BID #722 – Moorpark College – ANCT ZOO VISITOR BLEACHERS AND ANIMAL SHELTER

ADDENDUM 001, dated 01/29/2026

DRAWING changes and clarifications noted as Addendum 01 and dated 01/29/2026:

A102

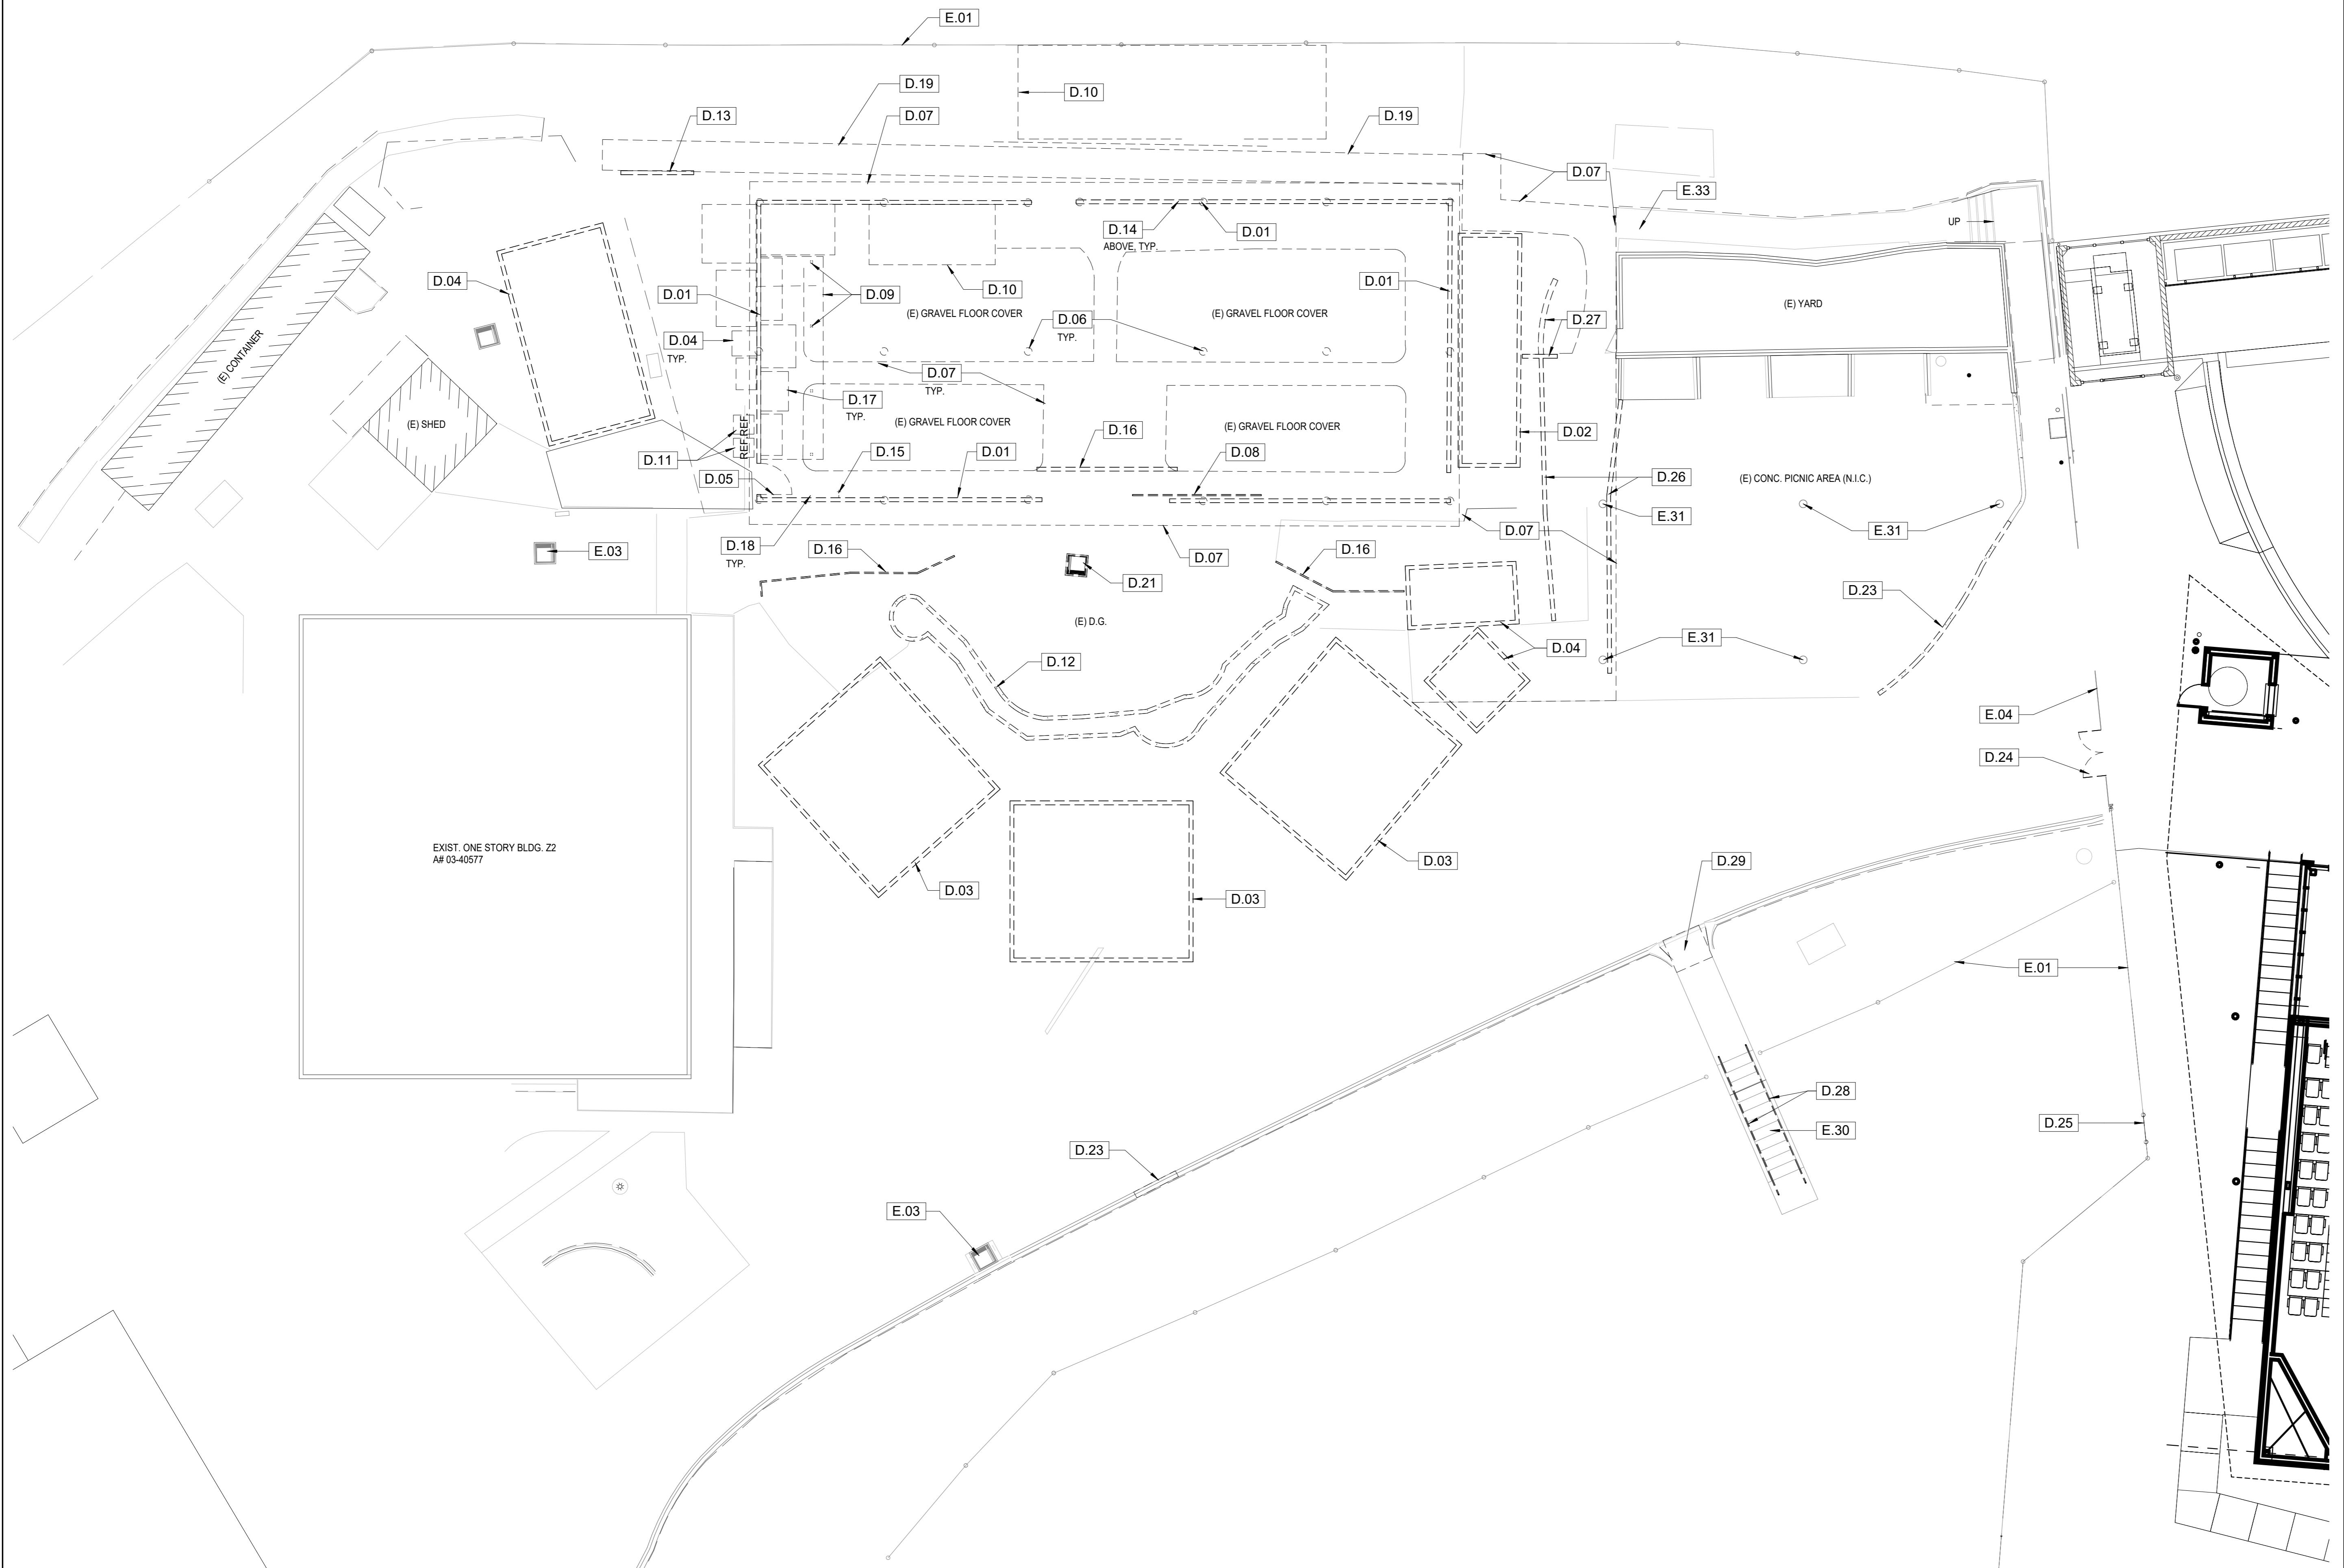
ADDENDUM 1 - PROVIDE AND MAINTAIN SCREENING FABRIC ON TEMPORARY FENCING FACING THE MAIN ACCESS ROAD. NOTE THAT THIS IS A HIGH WIND AREA.

I. Vehicular Directional Single Sided

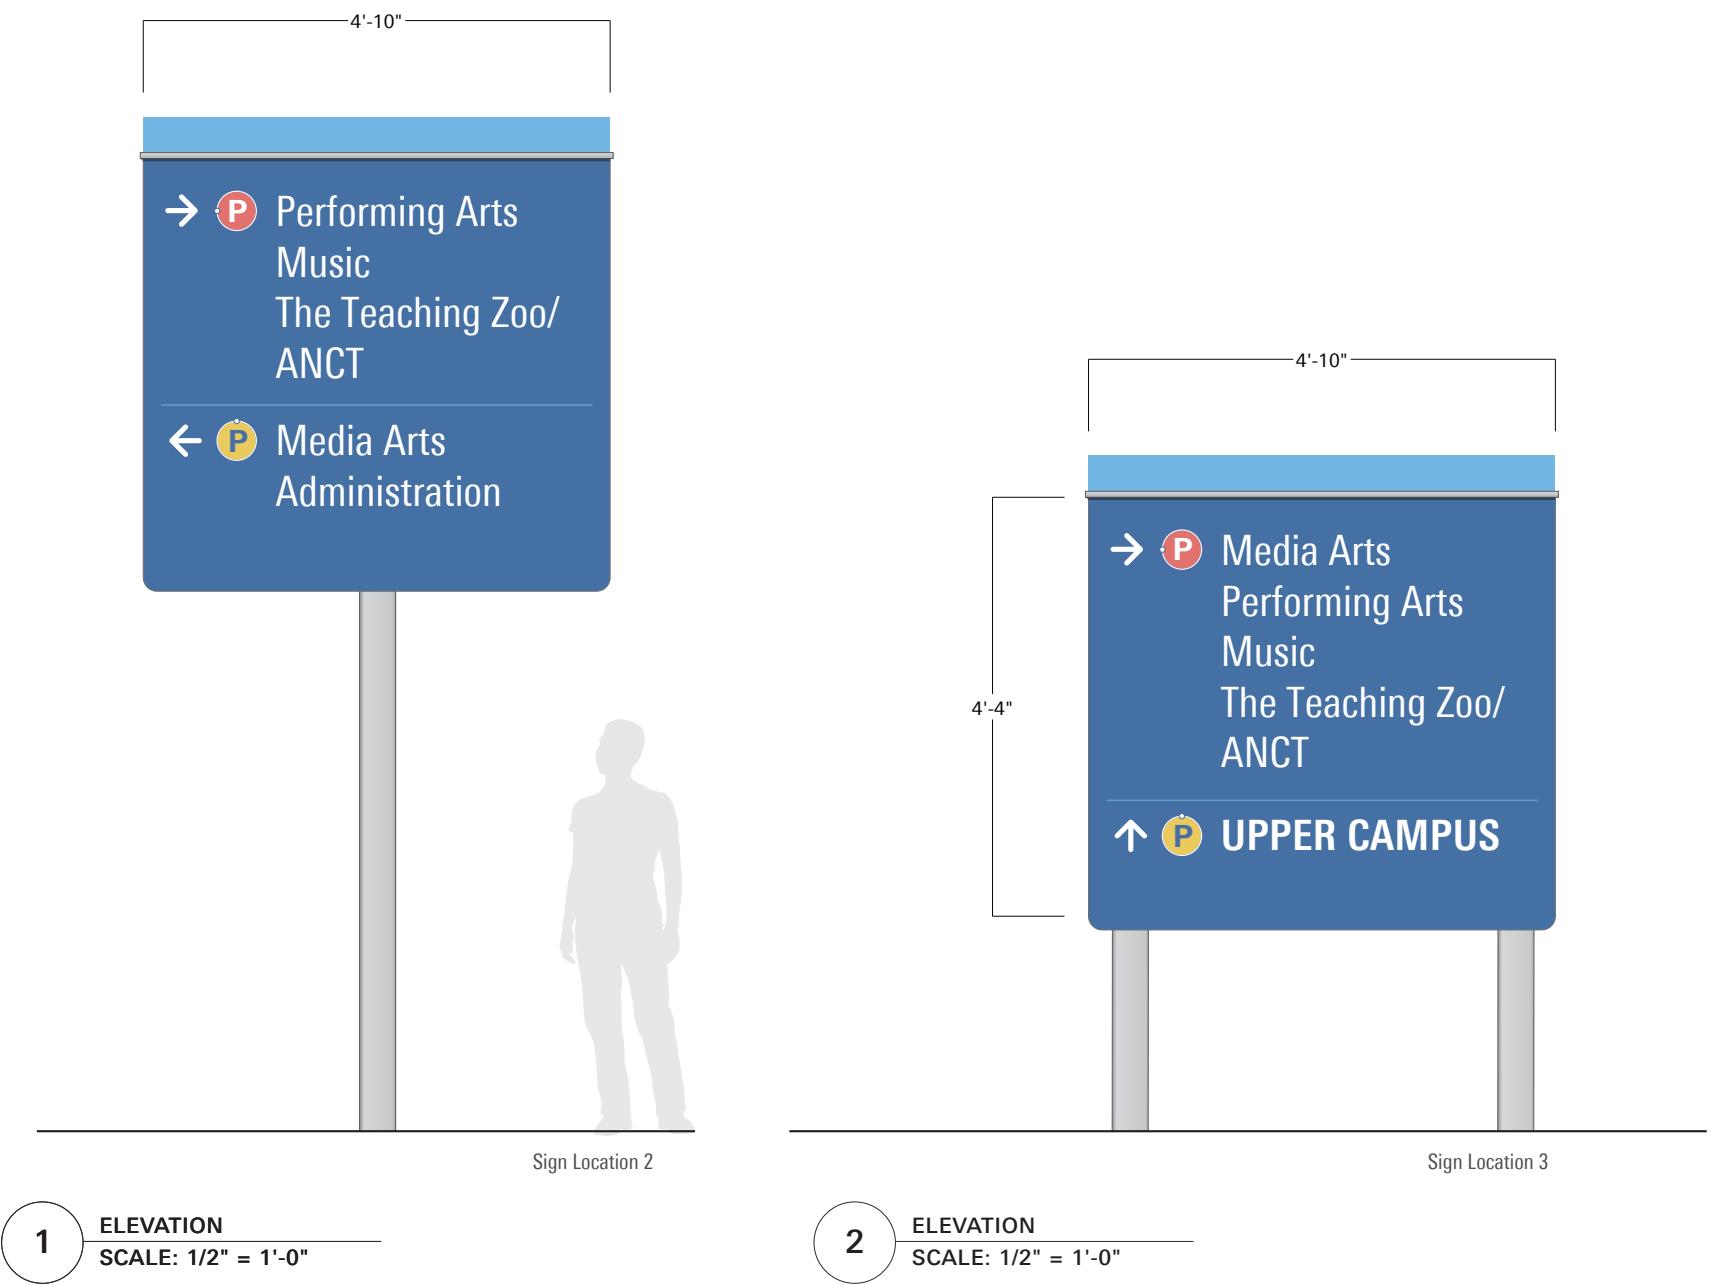
Update messaging on existing sign.

A. West Campus
Monument ID

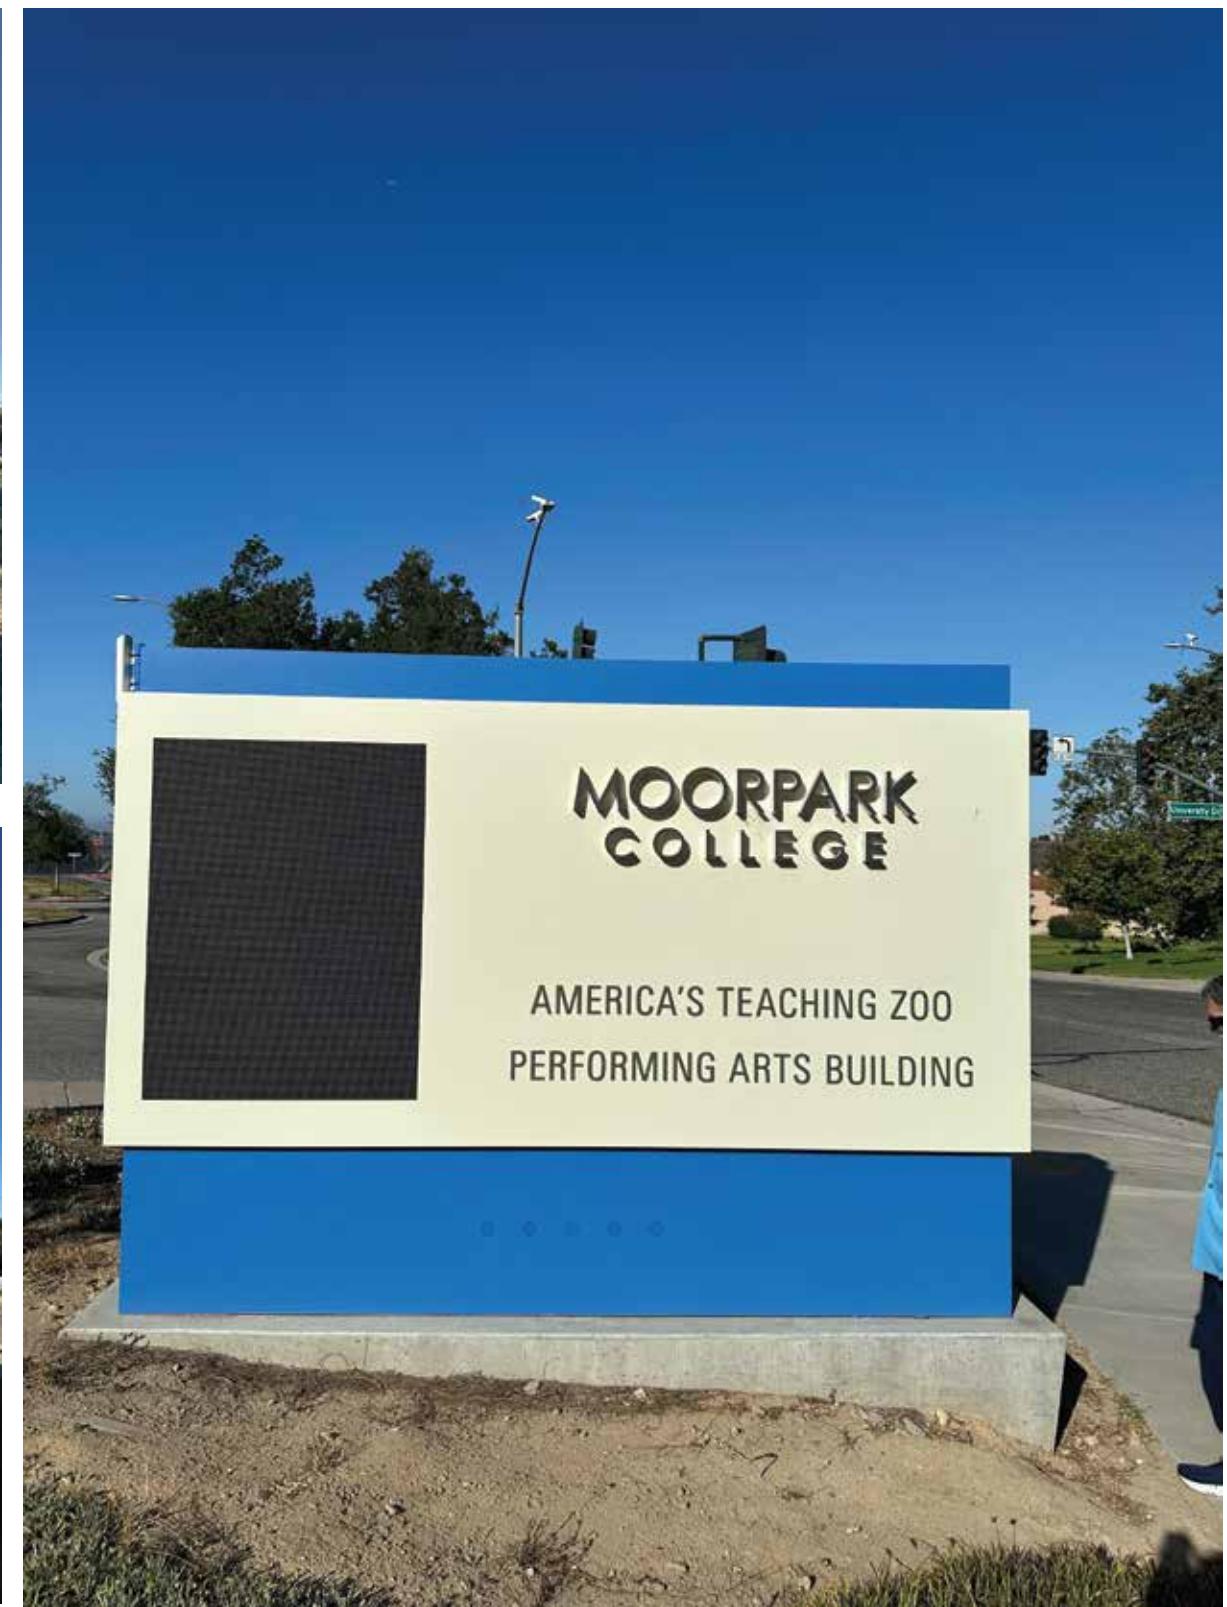
Replace existing aluminum face panels (double sided) plus the applied lettersets with visually equivalent assemblies paying special attention to:

Replace face panel with painted 3mm (1/8") solid aluminum composite material (ACM/no LDPE exposed edges). Match cassette-mounting to existing structure using available fastener holes or provide stable and durable adaptor. Isolate panel and fasteners from structure to prevent galvanic corrosion and thermal stress. Add anti-graffiti UV clear coat. Accommodate and protect existing electronic equipment during install. 2" deep side-lit or halo-edge LED lit fabricated aluminium letters stud-mounted through face panel into aluminum or stainless steel backer plates. Isolation gaskets between letter backs and face panels

Rear illuminated CNC-routed letter with UV-stable polycarbonate backer and dark translucent gray or charcoal diffuser. Mechanically retained behind panel with full gasket to prevent light leaks.

B. Zoo Monument ID

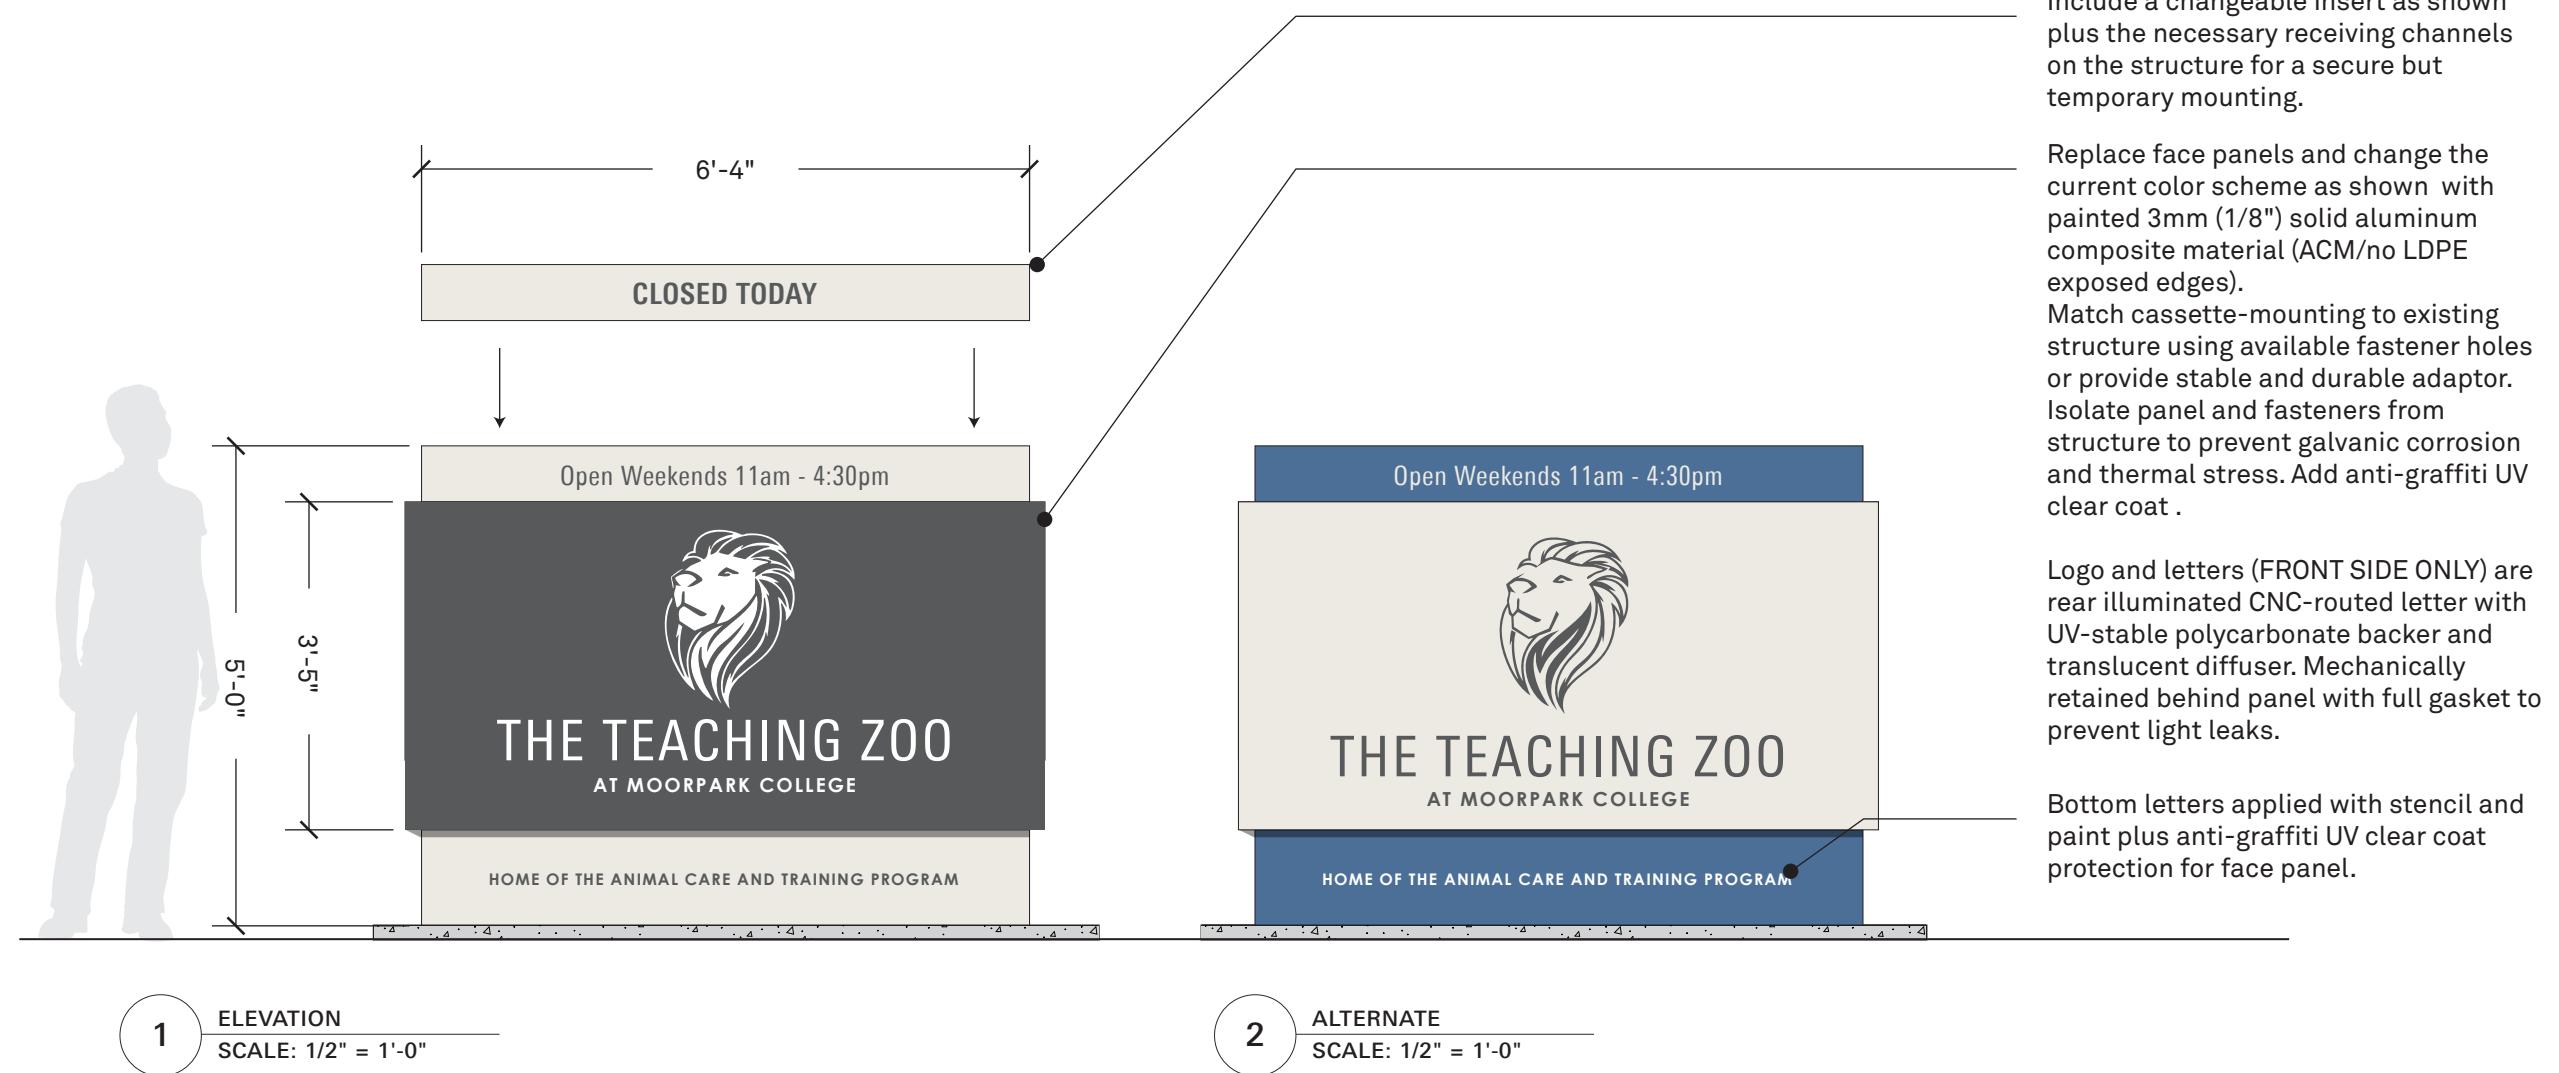
Replace existing aluminum face panels (double sided) plus the applied lettersets with visually equivalent assemblies paying special attention to:
